PRAIRIE ISLAND NUCLEAR GENERATING PLANT
Docket Nos. 50-282 License Nos. DPR-42
50-306 DPR-60

Status of Request for Relief from the Requirements
of Section XI of the ASME Boiler and Pressure Vessel Code

Request for Relief No. 59 - Revised Procedure

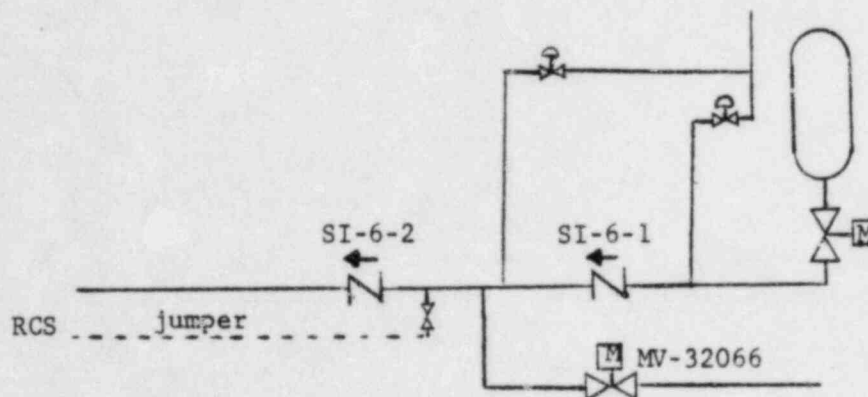
Page 3-4, 5 of NRC SER dated January 4, 1983 states that NSP has agreed to reverse the order of testing certain isolation valves.

We have revised the wording of the relief request to incorporate the desired order of testing (i.e., inboard or valves close to reactor coolant system should be tested last to minimize valve operation after leak testing). This cannot be accomplished for accumulator isolation valves, however, since Technical Specification Limiting Conditions for Operation (LCOs) require the accumulators to be operable under the plant conditions required for the valve tests.

The NRC Staff has requested us to test SI-6-1 and 32066 first, then SI-6-2. The back leakage of SI-6-2 can only be done by isolating the accumulator. We cannot isolate an accumulator when LCOs requires it to be in service.

This valve arrangement is tested in the following manner:

SI-6-2 is leak tested before placing accumulator in service

MV-32066 & SI-6-1 are leak tested by connecting a jumper between RCS & drain valve & monitoring change in ACC level & RHR pressure
